HISTORIC AND DESIGN REVIEW COMMISSION

HDRC CASE NO: 2020-560
ADDRESS: 344 MARY LOUISE
LEGAL DESCRIPTION: NCB 6698 BLK 7 LOT 16
ZONING: R-6, H
CITY COUNCIL DIST.: 7
DISTRICT: Monticello Park Historic District
APPLICANT: Joe Cano/All Pro Services of Texas
OWNER: COH LARA HYE-YOUNG
TYPE OF WORK: Roof modifications
APPLICATION RECEIVED: December 01, 2020
60-DAY REVIEW: Not applicable due to City Council Emergency Orders
CASE MANAGER: Huy Pham

The applicant is requesting a Certificate of Appropriateness for approval to replace a detached wood pergola with an attached rear roof addition for a covered rear patio.

2 NEW ELEVATION
SCALE: 1/8"= 1'-0"

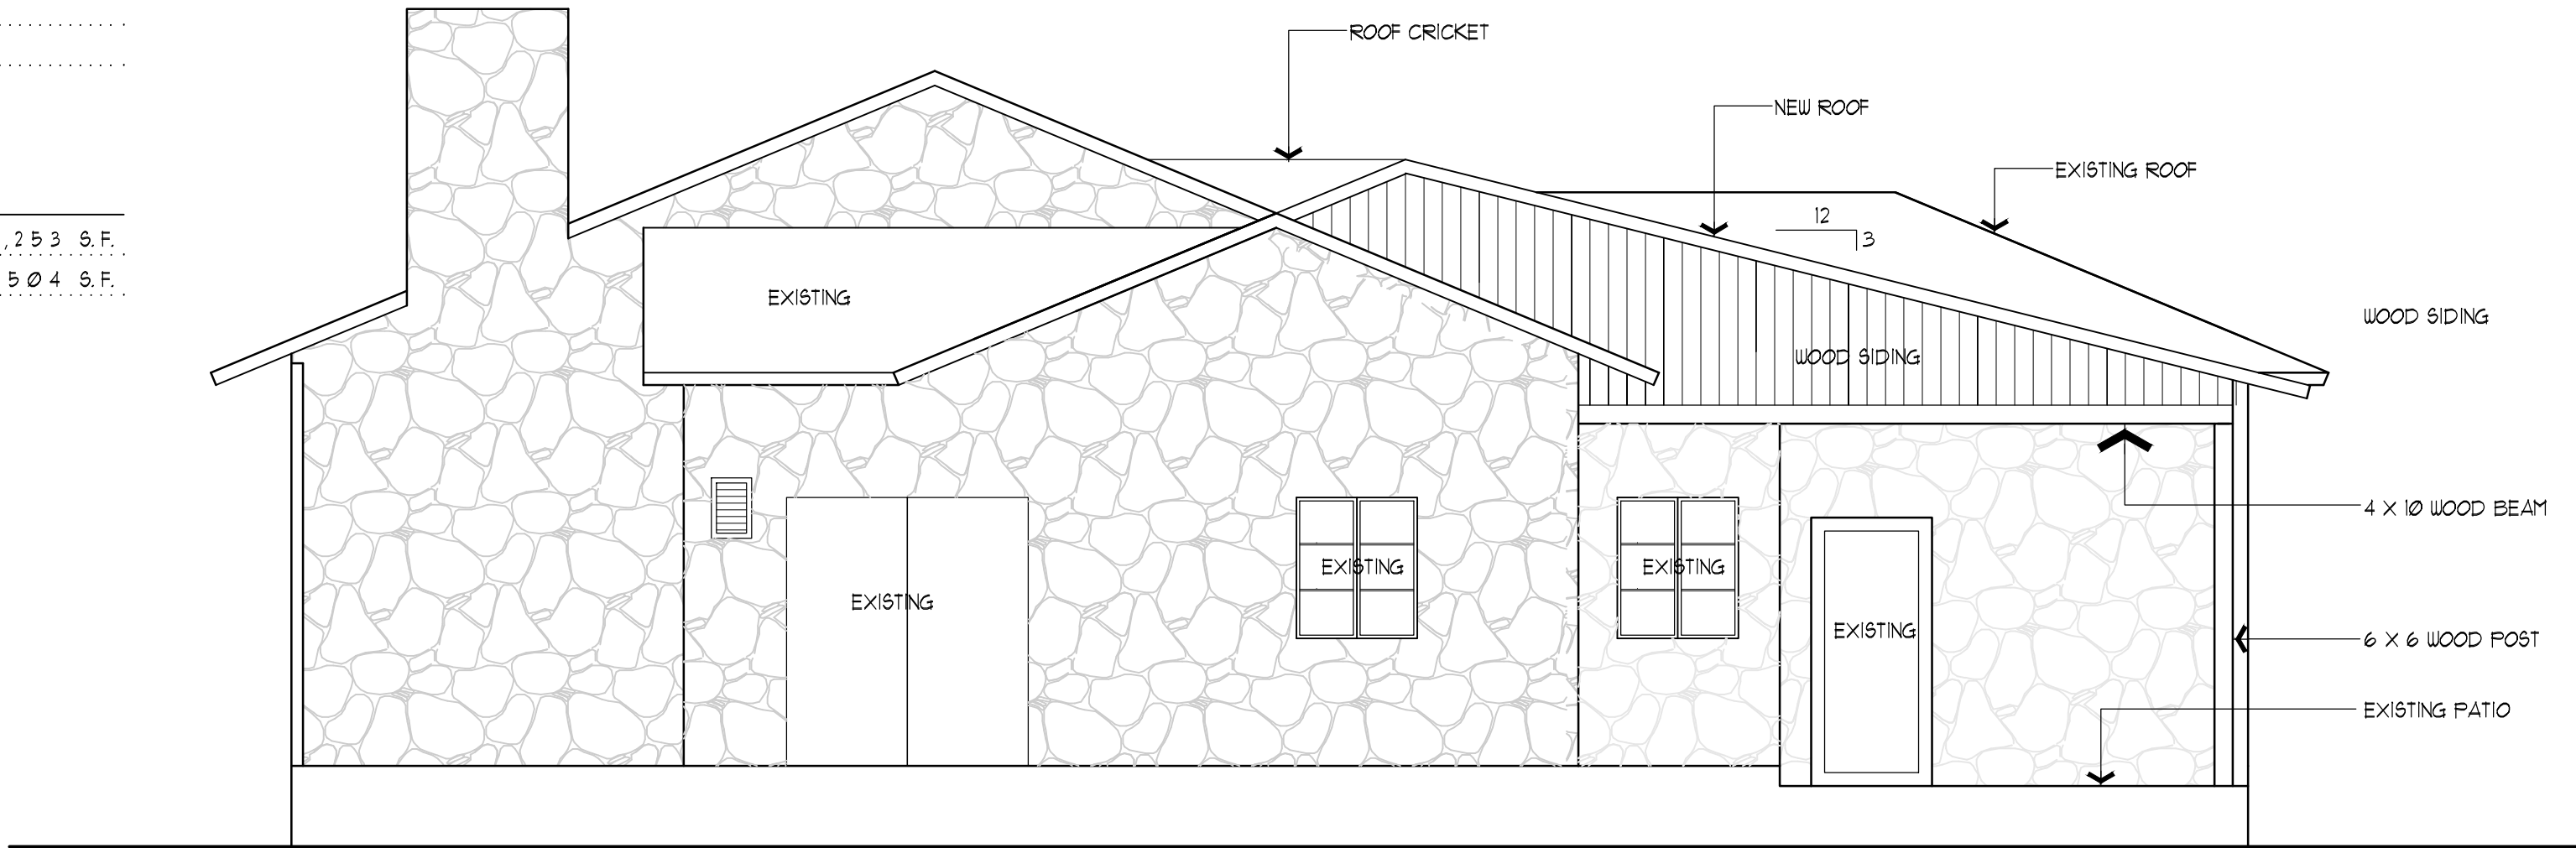
- d. ROOF DESIGN – The applicant has proposed for the porch cover to feature matching composition shingle roof with 12-3 slope, a vertical wood beadboard turned gabled face, 6-inch square wood posts, will terminate at south rear and west side wall planes. Per the Guidelines for Additions 1.A.iii., application utilize a similar roof pitch, form, overhang, and orientation as the historic structure for additions. As constructed, the pergola's roof features a profile that is inconsistent with the Guidelines for Additions as the proposed roof features a profile that is greater than that of the rear roof's slope.

Staff does not recommend approval based on finding d. Staff recommends that the pergola roof feature a profile and design that does not dominate the massing of the historic roof's structure. Staff recommends that the pergola's roof slope be modified to be subordinate to that of the historic structure's roof at the rear of the structure.

1 EXISTING ROOF PLAN & PROPOSED ROOF
SCALE: 1/8"= 1'-0"

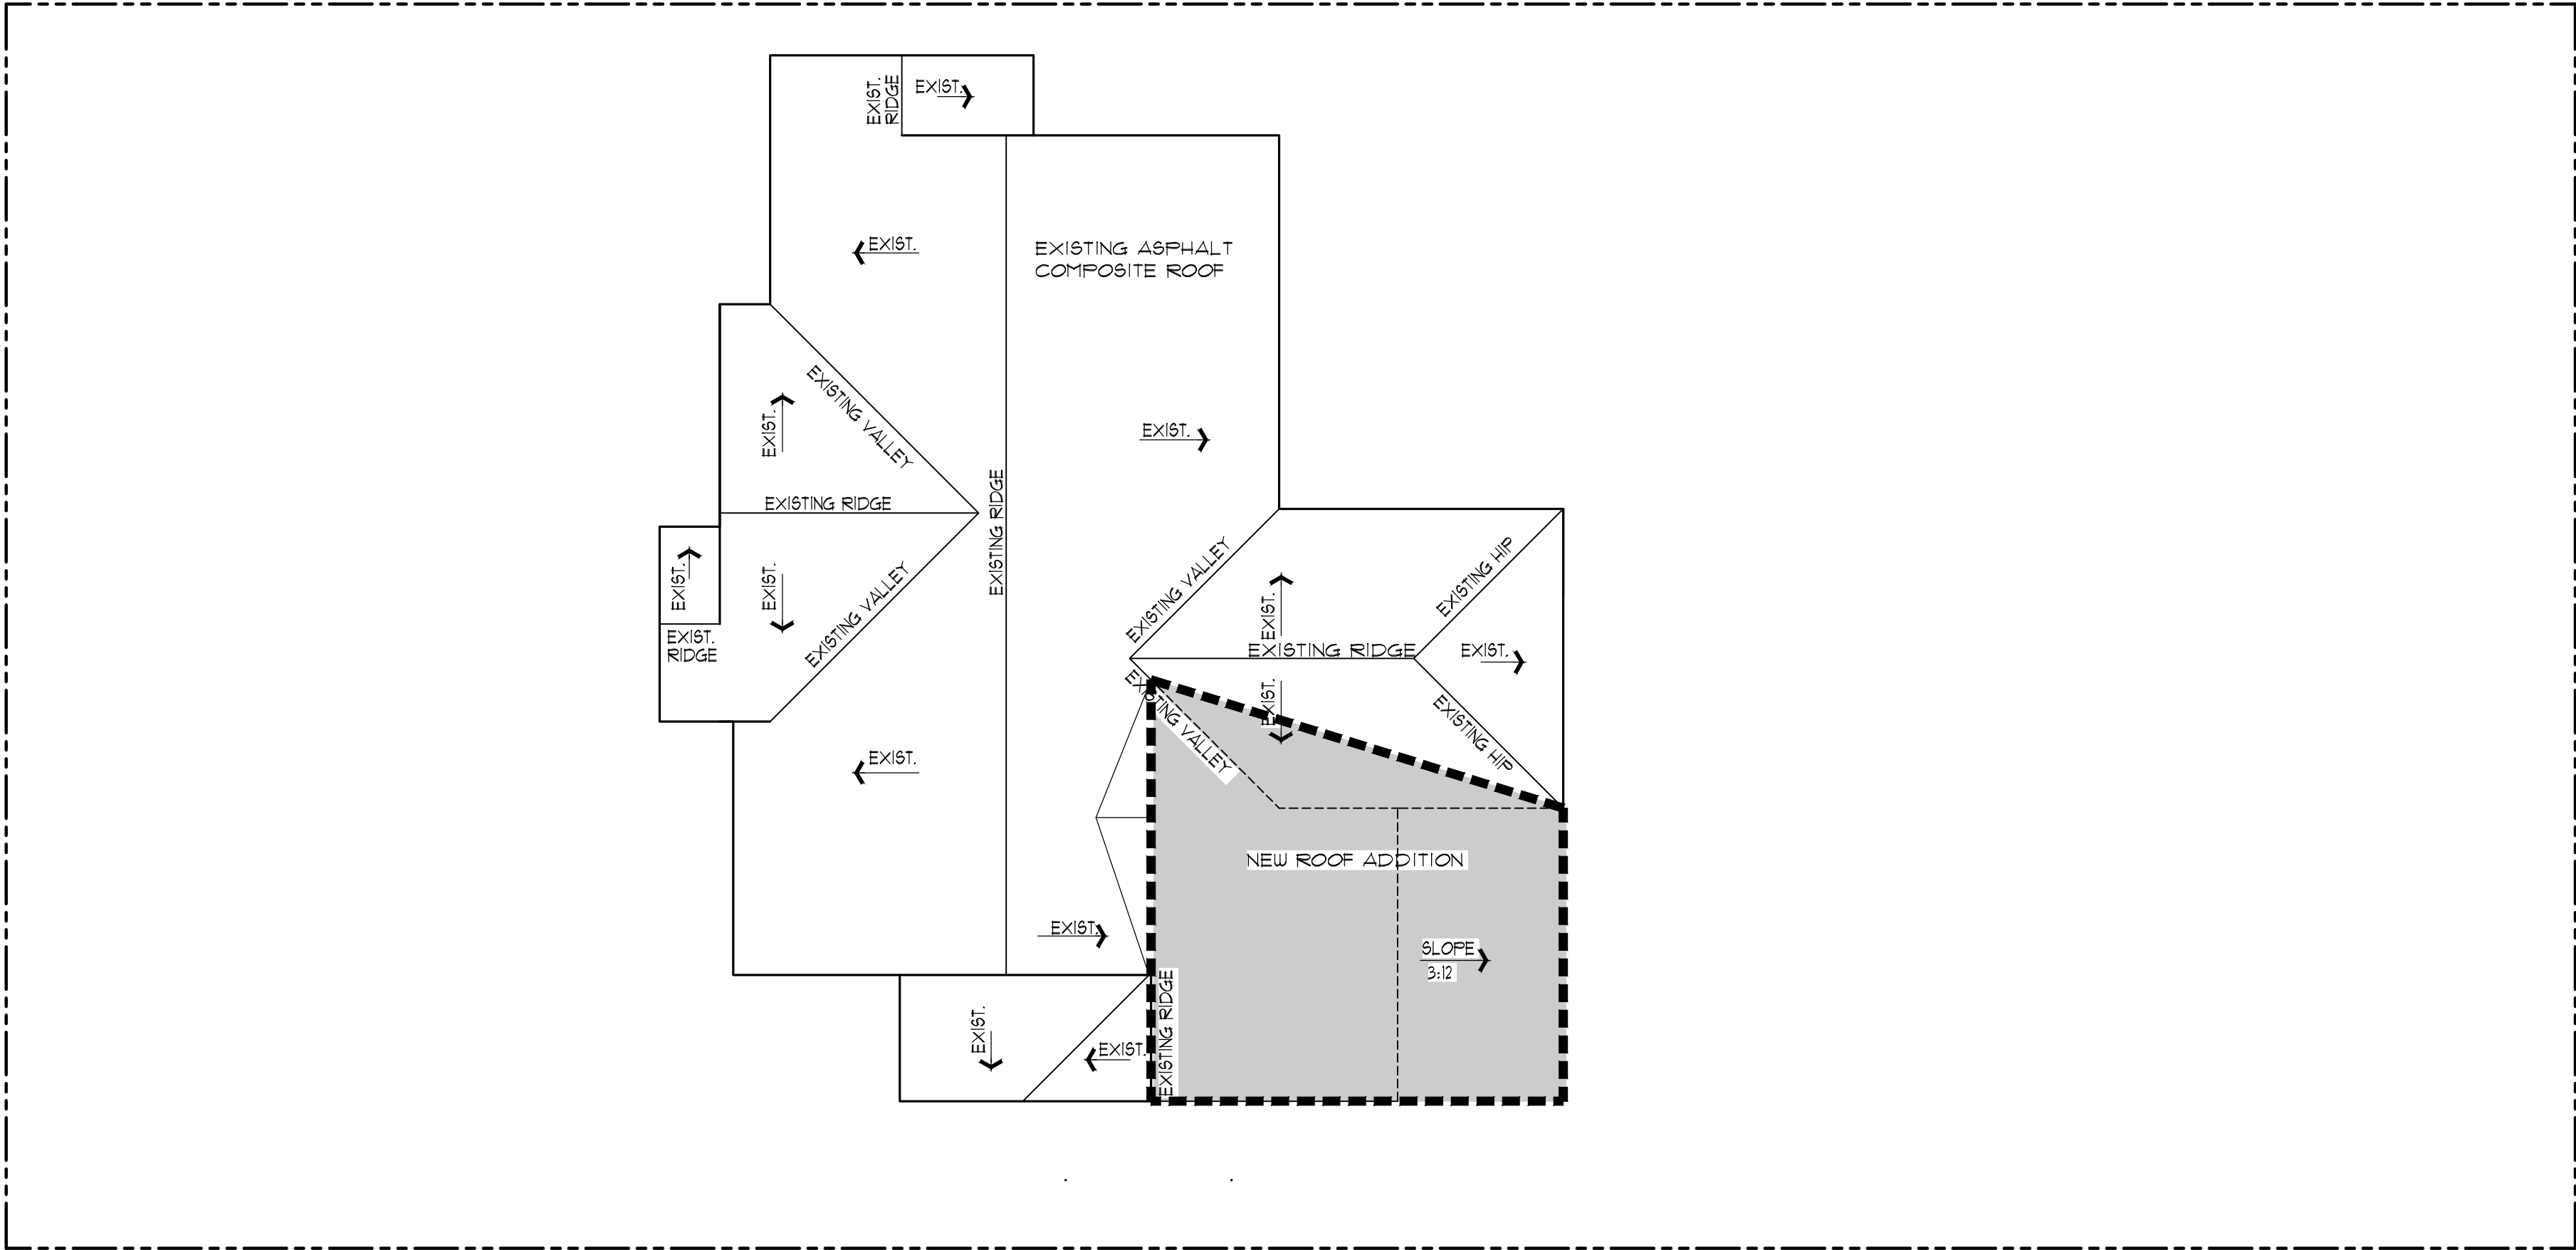
- c. REAR PATIO COVER -The applicant has proposed to replace a detached wood pergola with an attached rear roof addition for a covered rear patio. The porch cover will feature matching composition shingle, a vertical wood beadboard turned gabled face, 6-inch square wood posts, will terminate at south rear and west side wall planes. Per the Guidelines for Additions 3.1.A. applicants should site residential additions at the side or rear of the building whenever possible to minimize views of the addition from the public right-of-way. Staff finds that setting the roof addition to the rear is appropriate.
